METROPOLITAN GOVERNMENT OF NASHVILLE AND DAVIDSON COUNTY

STAFF RECOMMENDATION 1404 Lillian Street December 18, 2019

Application: New Construction—Infill
District: Lockeland Springs-East End Neighborhood Conservation Zoning Overlay
Council District: 06
Map and Parcel Number: 08313032300
Applicant: Katheryn Sullivan, Owner
Project Lead: Sean Alexander, sean.alexander@nashville.gov

sheet no.
A1

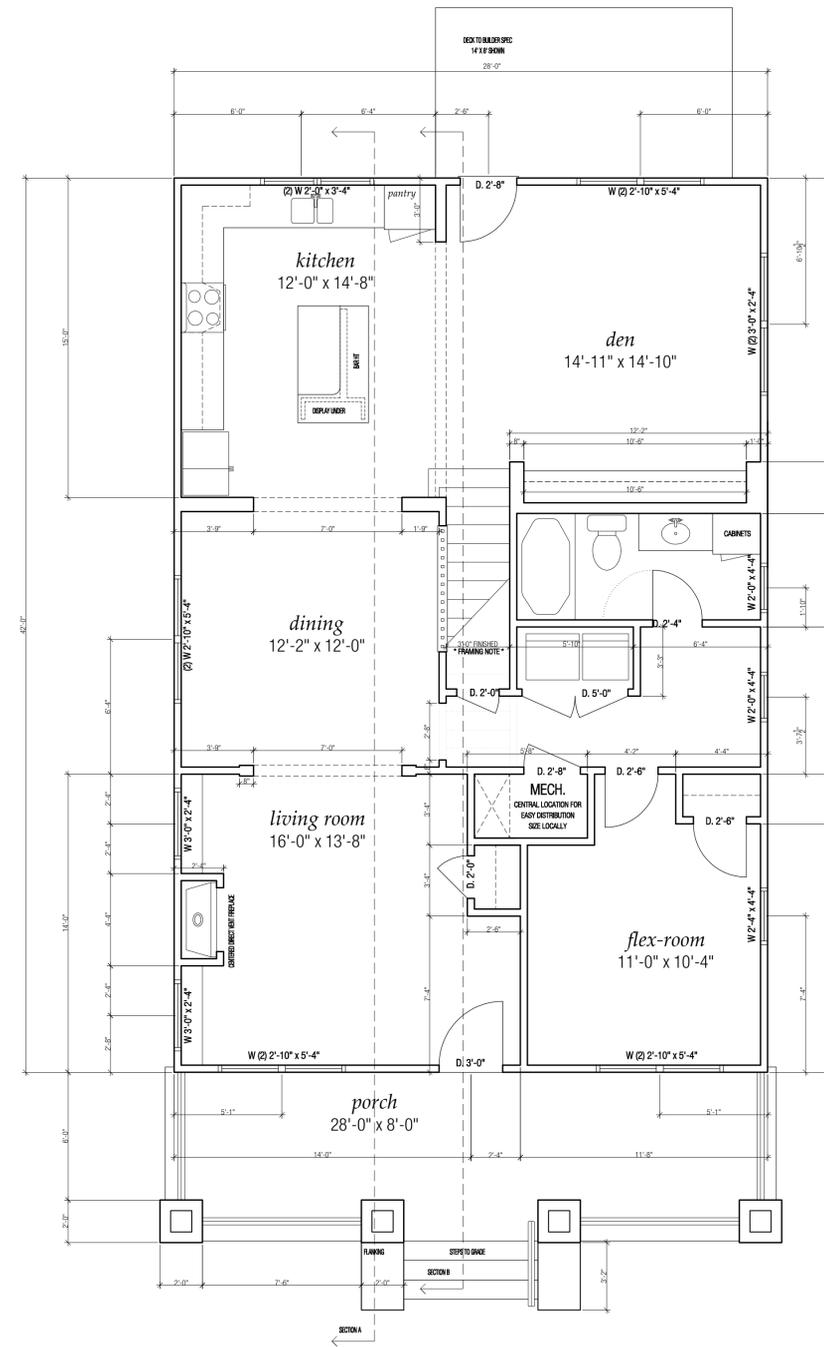
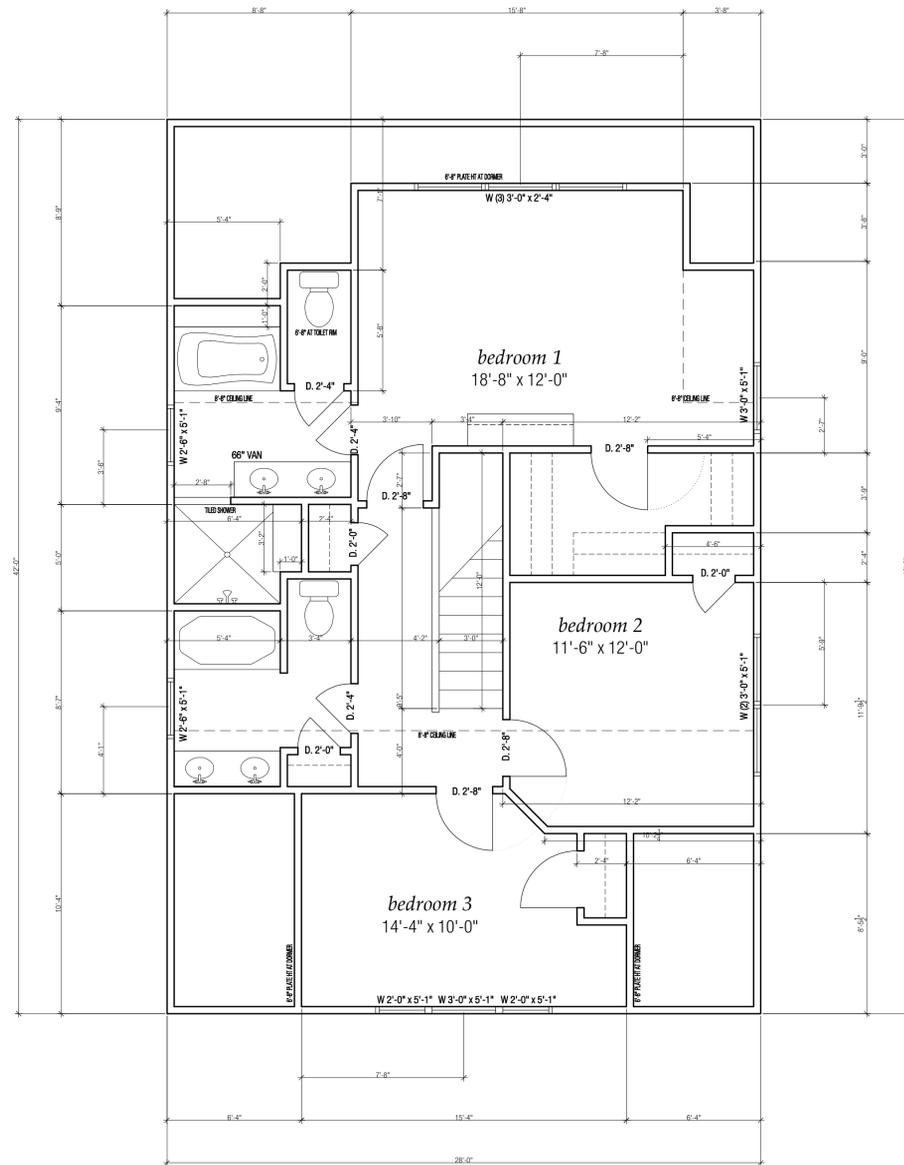
Height & Scale: The proposal is for a one and one-half story building with a roof height of twenty-five feet (25’) above the finished floor level with an eave line at nine feet, six inches (9’-6”) above the floor level. The plans depict the floor level as being three feet (3’) above grade with an exposed foundation giving it a total height of twenty-eight feet (28’) from grade. Recently approved infill on the street range between twenty-four feet (24’) to thirty-two feet (32’) tall from grade, with eave heights ranging from approximately nine feet, six inches (9’) to thirteen feet (13’).

The plans show that the house will be twenty-eight feet (28’) wide, whereas Metro tax assessor records show the existing building to be only twenty-six feet (26’) wide. Since the applicant has stated that the house will use the existing foundation, Staff asks that the applicant clarify this discrepancy and submit corrected drawings, if applicable. Either width is compatible with nearby buildings, which range from twenty-six feet (26’) to thirty-five feet (35’) wide; however, the drawings associated with a permit need to be correct in order to adequately communicate the project to the inspector and to clarify what was approved.

With the condition that applicant clarify any discrepancies between the plans and what will be constructed and submit corrected drawings, if applicable, staff finds that the massing and scale of the proposal are compatible with the surrounding context and that the project meets sections II.B.1 and II.B.2 of the design guidelines.

sheet no.
A2

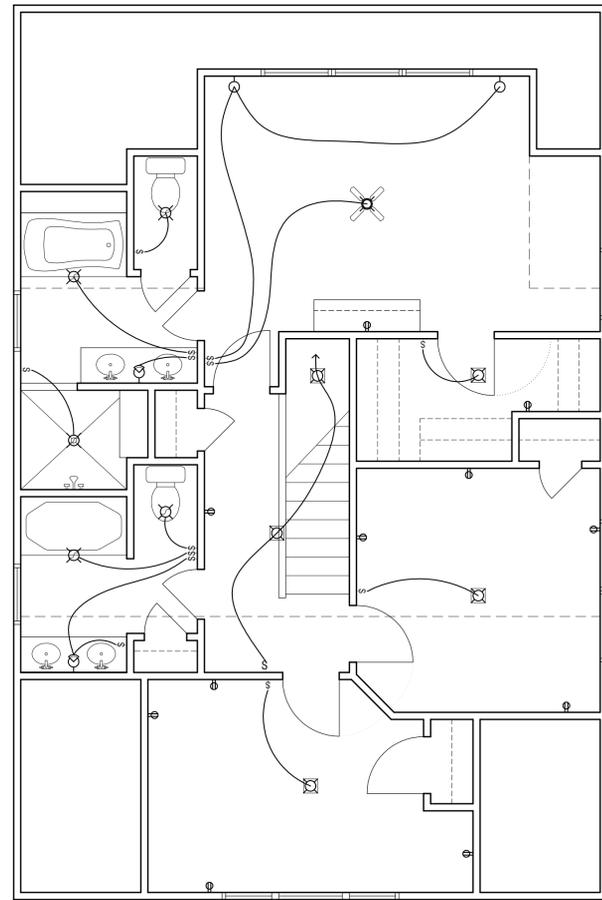
Roof form: The roof on the new house will have a side-gabled roof with a pitch of 8/12, and a gabled dormer on the front slope with a matching pitch. The front dormer is shown with the front wall sitting directly over the front wall of the first story below, whereas dormers historically were typically stepped at least two feet (2') back from the primary front edge of a building.

As a condition of the 2016 approval for 1404 Lillian Street, the Commission required the front dormer to be stepped back at least two feet (2') from the front wall of the building. Historically, dormers were generally constructed to be stepped back from the front wall of a house. This stepped-back condition has been required for nearly all additions and infill projects approved by the Commission previously.

Staff recommends that the front dormer be constructed so that its front wall is stepped back to the point where the porch meets the primary roof rather than aligned above front wall of the house, to be more typical of dormers on houses historically and infill approved by the MHZC.

Proportion and Rhythm of Openings: The applicant has indicated by email that the first story window patterns will remain as they are currently, but the submitted plans depict different window locations and sizes on both side elevations. Staff asks that the applicant clarify these discrepancies and submit corrected drawings, if applicable.

As shown on the plans, most of the windows will be twice as tall as they are wide, as is typical of windows on historic buildings. On the left side, the first story and upperstory windows are roughly equal in size, as is typical of windows historically. However, all of windows on the first story on the right side are depicted as being shorter and narrower than those in the upperstory. On historic buildings, first stories are typically taller than upper levels, so the windows on each level were either of similar dimensions or the first level had windows taller/larger than the upper level. Having taller windows on the upper level, as proposed, creates a "top-heavy" design that is not consistent with the proportions of openings on houses in the historic context.

There are no large expanses of walls on the right side without any openings, but on the left side, toward the back, there will be approximately eighteen feet (18') of wall-span without any door opening. Staff finds this to be appropriate as the rear-side of the building will have minimal visibility from the street.

With a condition that the front dormer shall be stepped back two feet (2') from the wall below, staff finds that the roofs of the current proposal would be compatible with surrounding historic houses and would meet section II.B.5 of the design guidelines.

Staff also recommends a condition of approval be added that the applicant shall submit corrected drawings clarifying how the roof, kneewall, and dormer will be constructed.

Staff recommends submittal of new drawings that accurately reflect the desired window configuration, and that the first story windows are generally as large or larger than those of the upperstory. With this condition, the project can meet section II.B.7.
